Providence City Plan Commission

AGENDA ITEM 3 ■ 188 PRINCETON AVE

OVERVIEW

Site plan

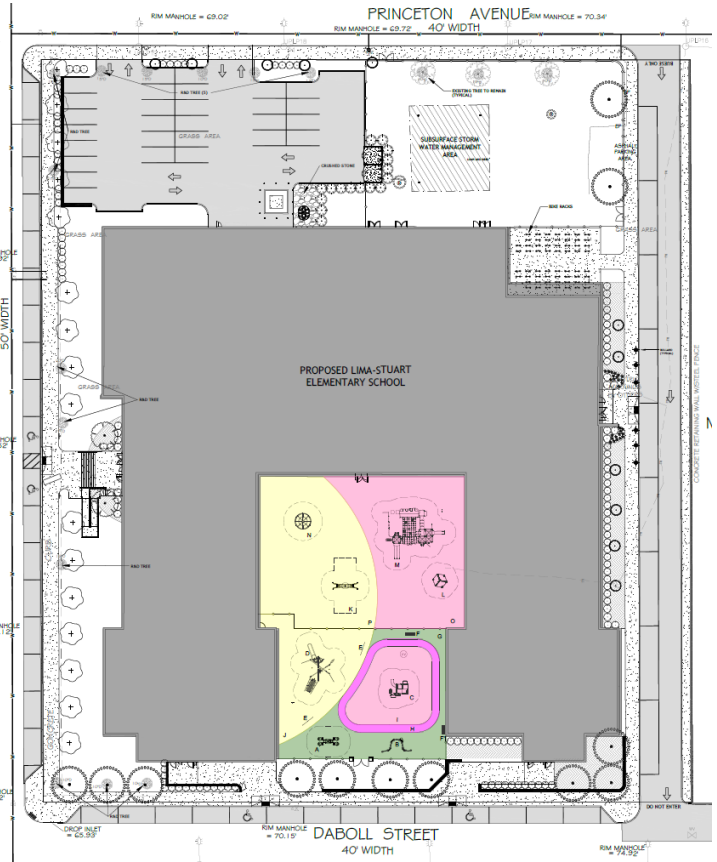
to the west, Daboll Street to the south and the C-2 zone to the east. A bus lane will be located between the building and the eastern lot line. The building will exhibit a horseshoe layout with vertically laid out wings connected by a horizontal section in the rear. The fronts of the vertical wings will be set to Daboll Street with the main entrance on Bucklin Street and a separate middle school entrance on the east side of the building. A parking area and playground will be located at the rear fronting on Princeton Ave. Additional play areas for pre-K and first grades will be located between the vertical wings. Floor plans show the building’s programming on each floor will consist of a mix of classrooms, activity spaces and staff rooms.

Twenty parking spaces are needed to meet the requirement of one space per three employees with 60 employees expected. The applicant will meet the parking requirement, providing 28 spaces in the parking area with an additional 39 spaces in satellite lots. In addition, 32 curbside spaces will be provided for pick up/drop off on Bucklin and Daboll Streets. A total of 120 bicycle parking spaces will be to meet the requirements of three bike spaces per classroom.

The PS zone requires 30% of canopy coverage for the 140,000 SF lot size amounting to approximately 42,000 SF. The applicant will meet this requirement by planting 41 large trees around the site. Approximately 44,000 SF of canopy coverage will be provided when counting the coverage provided by three existing trees. The plan notes that the width of the planting strip adjacent to the parking area varies between 4' and 4'5", which is slightly less than the 5' required. The applicant is required to obtain a modification from the City Forester for the decreased length.

1. The applicant and their traffic engineers shall work with the City Traffic Engineer on implementation of the recommendations in the traffic memo.
2. The drainage plan shall be subject to the City Engineer's approval.
